**Petition 22-11
Tim Raymond on Behalf of TMF Plastic Solutions, LLC
Site Plan Approval**

ENGINEERING PLANS FOR TMF MANAGEMENT, LLC PARKING ADDITION

Subject: 12127B Galena Road TMF Management South Parking Lot Addition
(WBK Project 19-102.AK)

RE: *Site Plan Approval for Building Addition*
12127 Galena Road, Unit B, Plano, Little Rock Township (PIN # 01-01-200-002)

TMF PLASTIC BUILDING ADDITION
OVERALL SITE PLAN

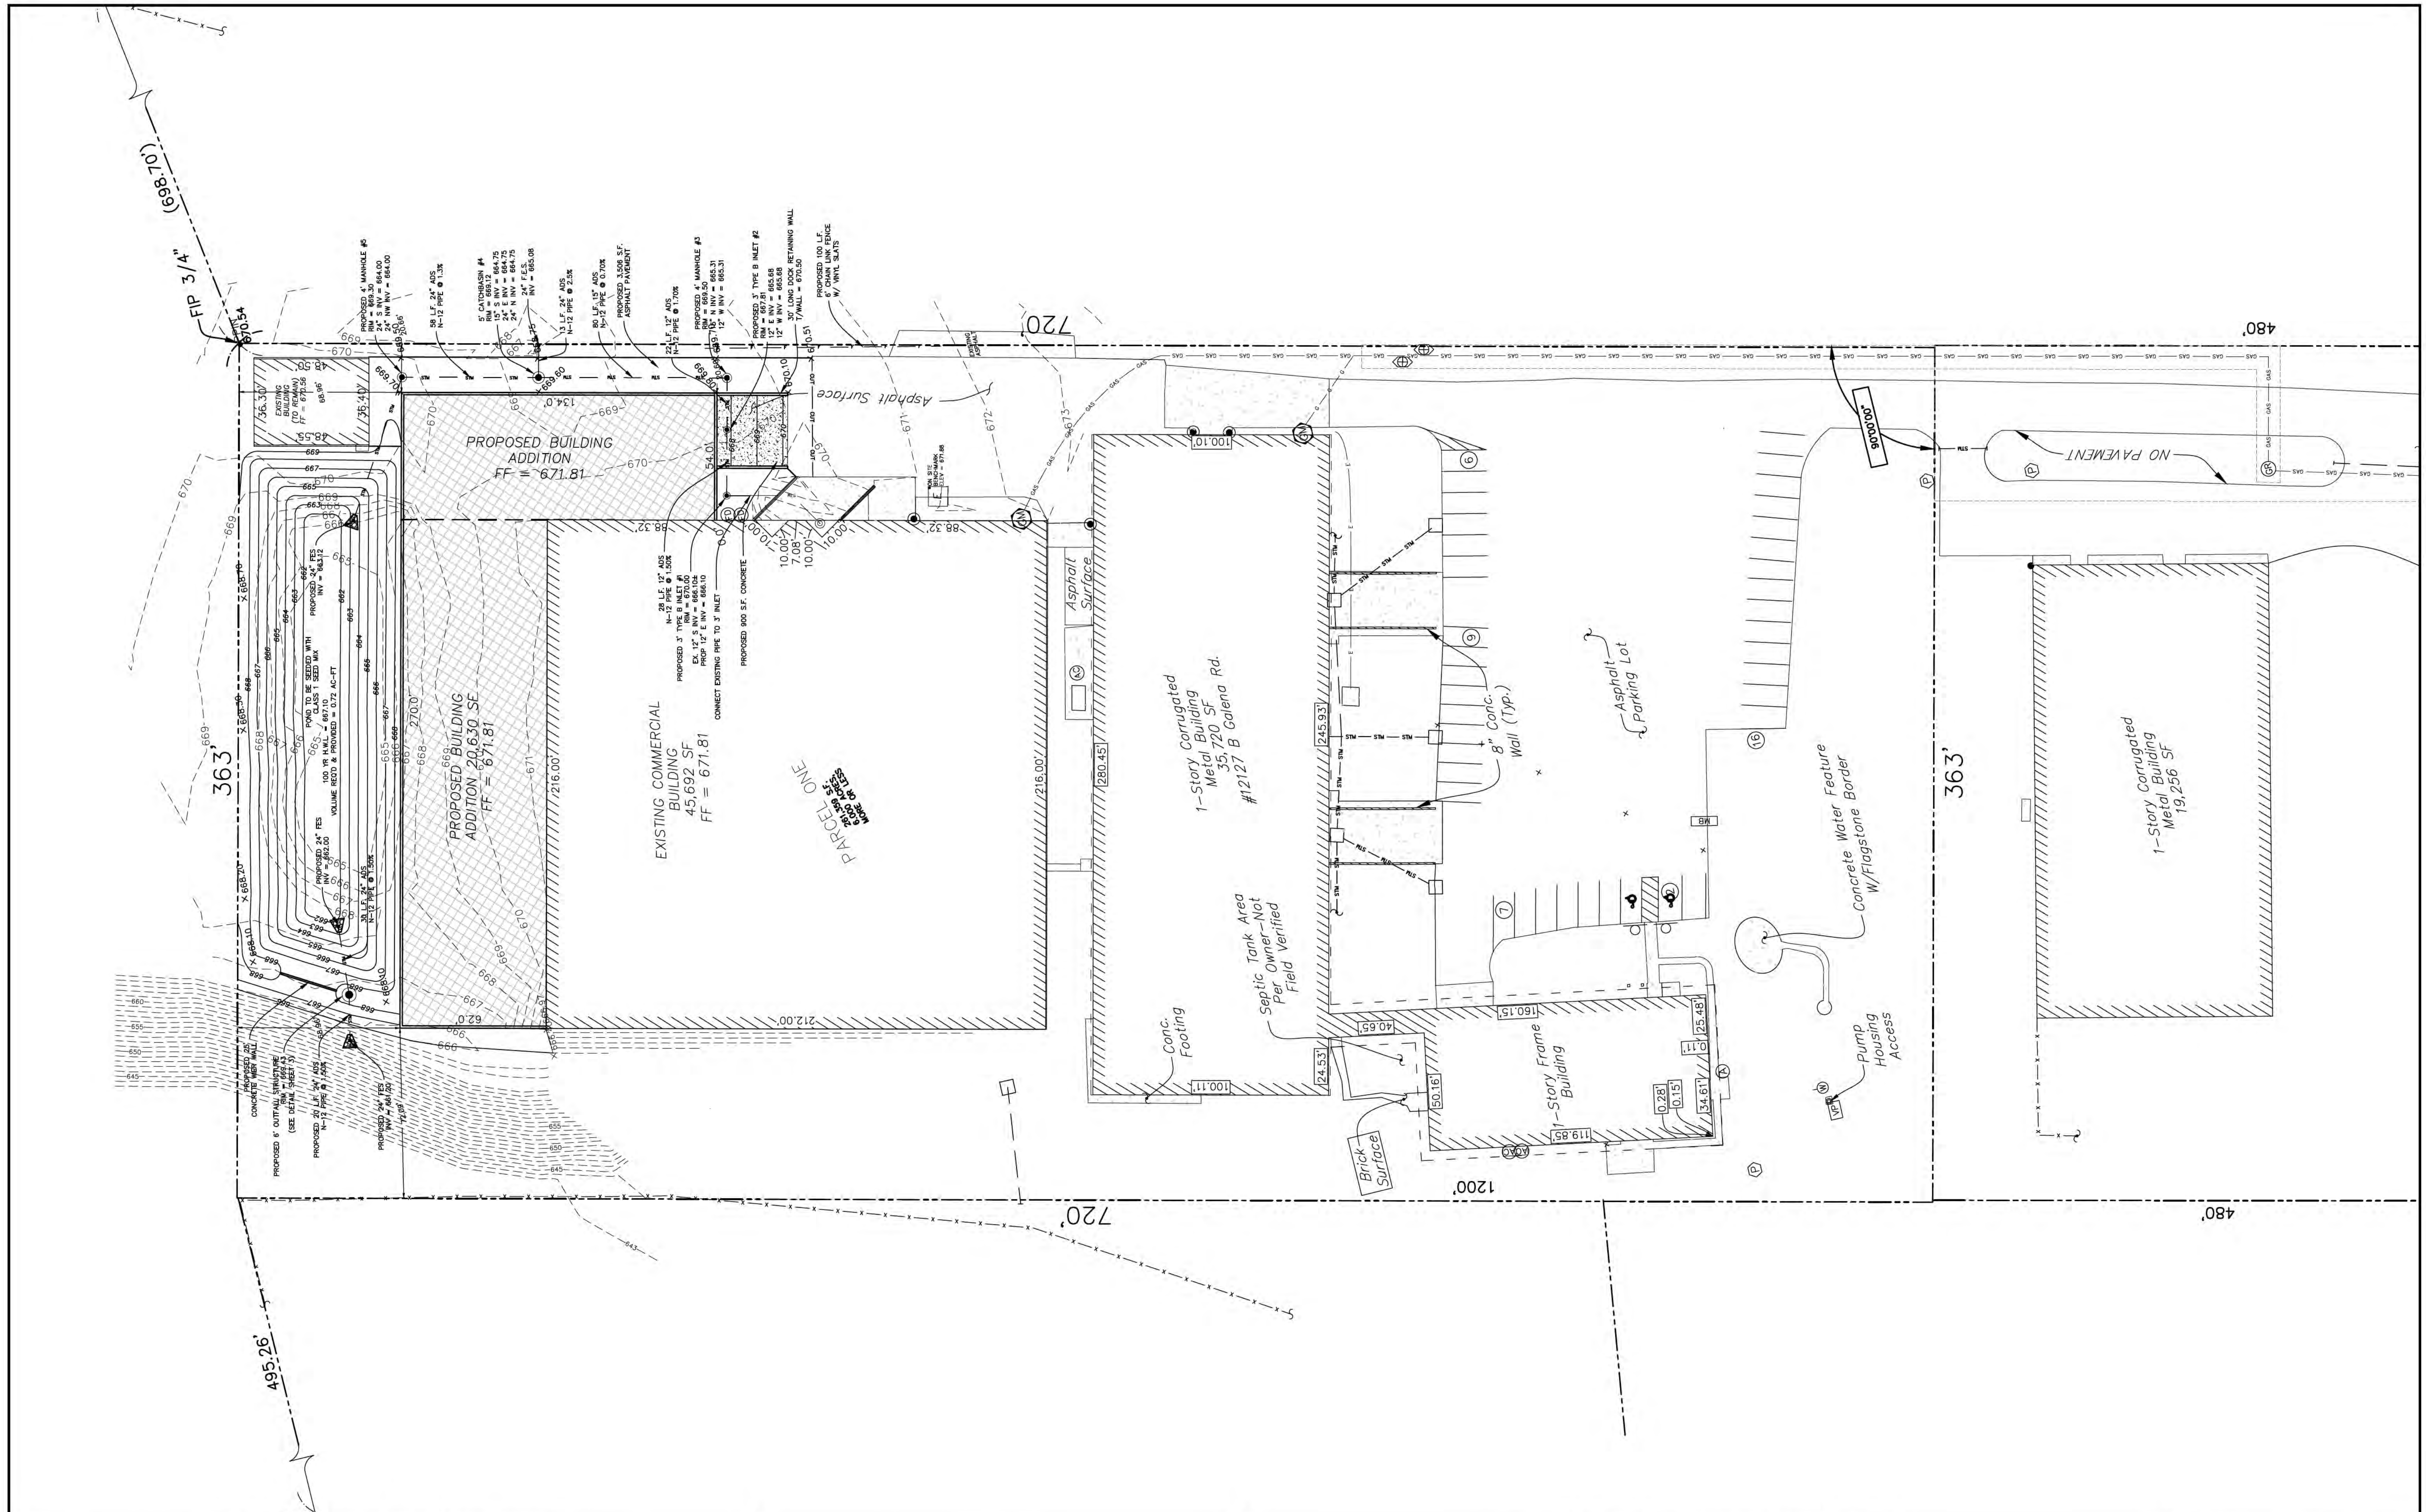
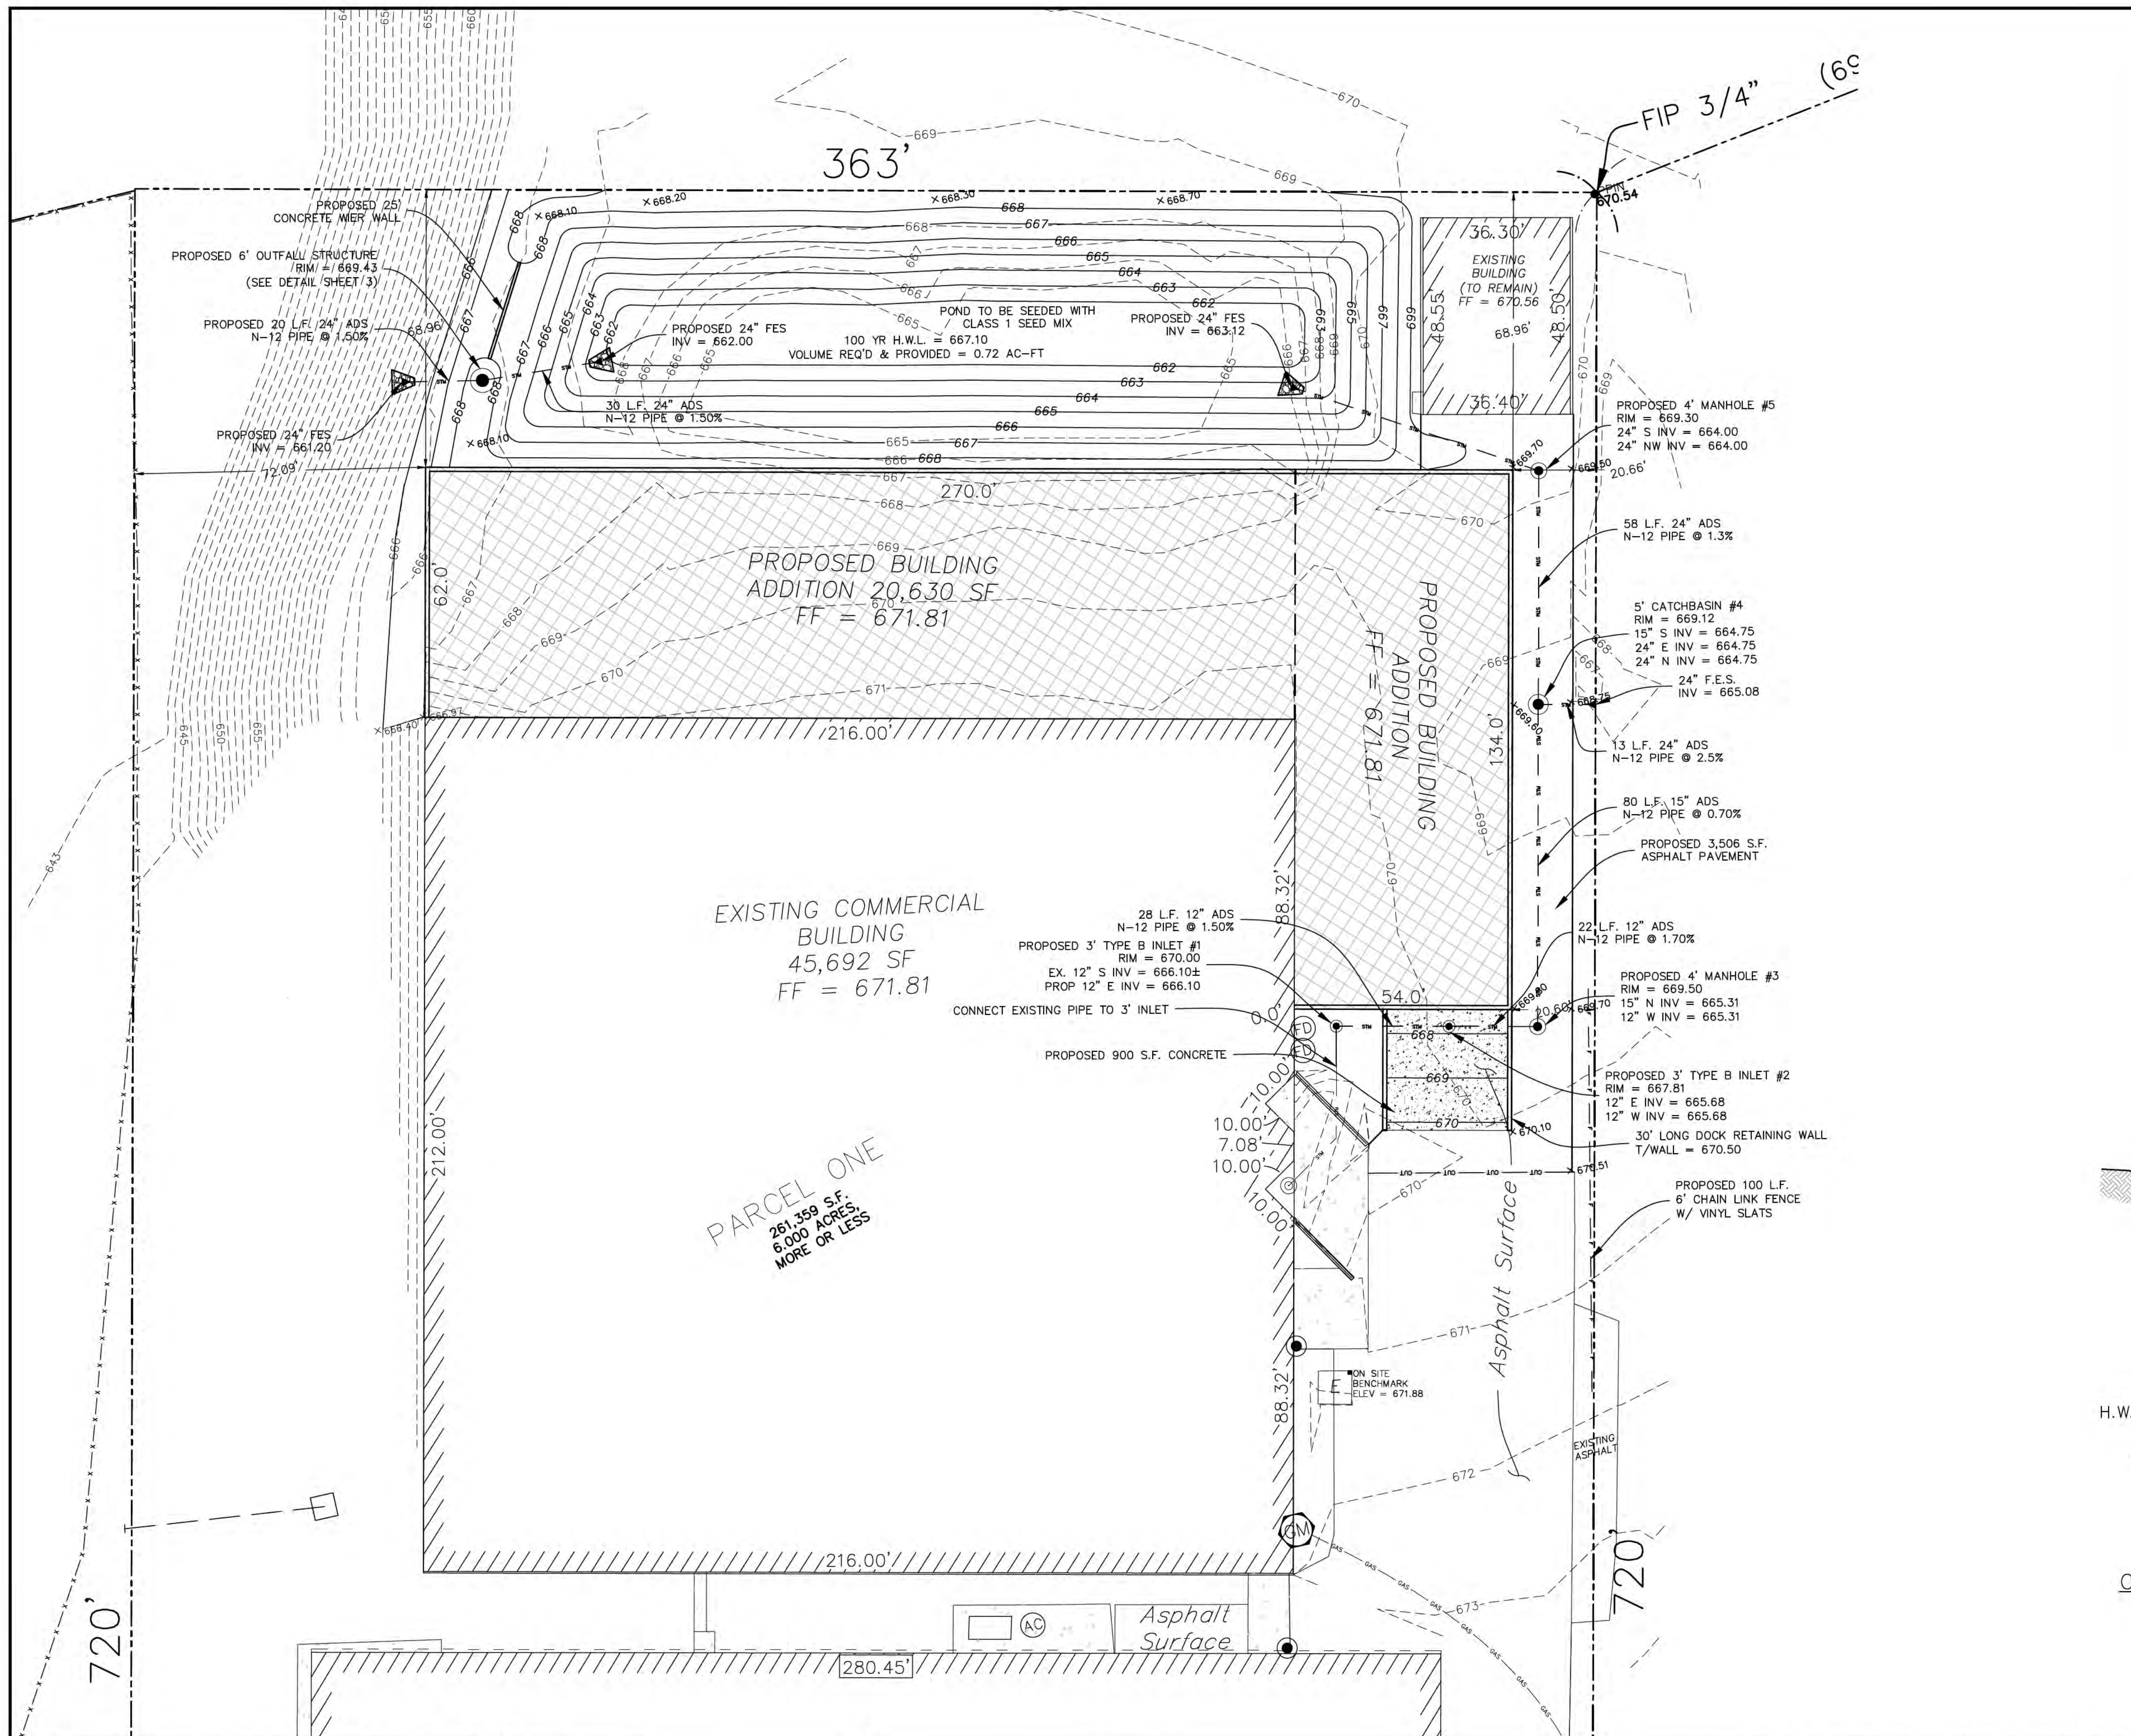
1. The zip code was corrected.
2. We did find that there were two signs in the parking lot, so we added a second striped handicap stall.
3. The north doors do not require any access drive.
4. The facility runs 3 shifts and has 32 employees per shift. There are no company vehicles.
5. We have added a 6' chain link fence with vinyl slats along the east property line in front of the docks.
6. The back area near the docks acts as a loading berth.
7. Side and rear yard setbacks are detailed off the corners of the building. The setbacks meet the M-I zoning requirement.
8. There is no mechanical equipment on the roof. No HVAC on this building addition.
9. The lighting levels at the property line meet the 0.2 requirements.
10. The addition does not need any refuse containers.
